Docket: NRC-2016-0231

Waste Control Specialists LLC's Consolidated Interim Spent Fuel Storage Facility Project

Document: NRC-2016-0231-DRAFT-0339

Comments on CIS DEIS
By
Marvin Resnikoff, Ph.D.¹
Radioactive Waste Management Associates
September 2020

Figure 1. Rail Fires, Yrs 2000 – 2009.

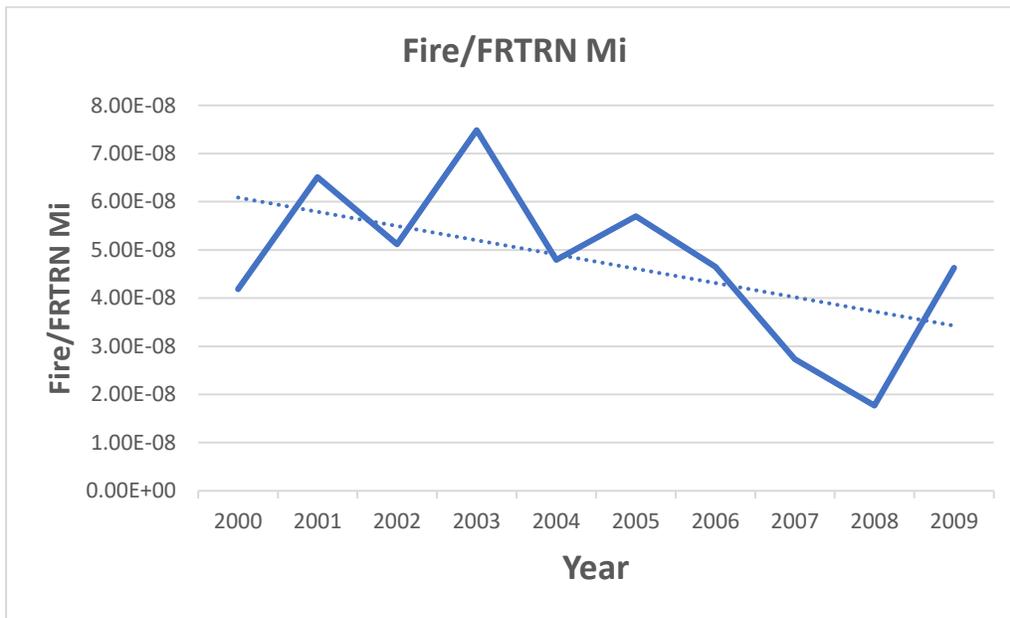
While the rail accident rate, according to FRA, has declined in the years between 2010 and 2018, the same is not true for the fire accident rate, which has risen over the same years. Our review of the FRA data show 392 accidents involving fire of varying severity between the years 2010 through 2018, ranging between 16 and 79 fire accidents per year. Comparing the periods 2000 to 2009 considered in NUREG-2125, and the period 2010 to 2018, the fire accident rate has almost doubled. NRC staff should consider the most recent data. Graphs showing rail fires per freight train mile for the years 2000 – 2009, and years 2010 – 2018 appear as Fig. 1 and 2, respectively. The reason for this increase of fire accidents is not difficult to understand; more tanker cars are on the rail, mainly from North Dakota to refineries on both coasts.

The bottom line is more fires have been occurring per accident than is acknowledged by NUREG-2125.
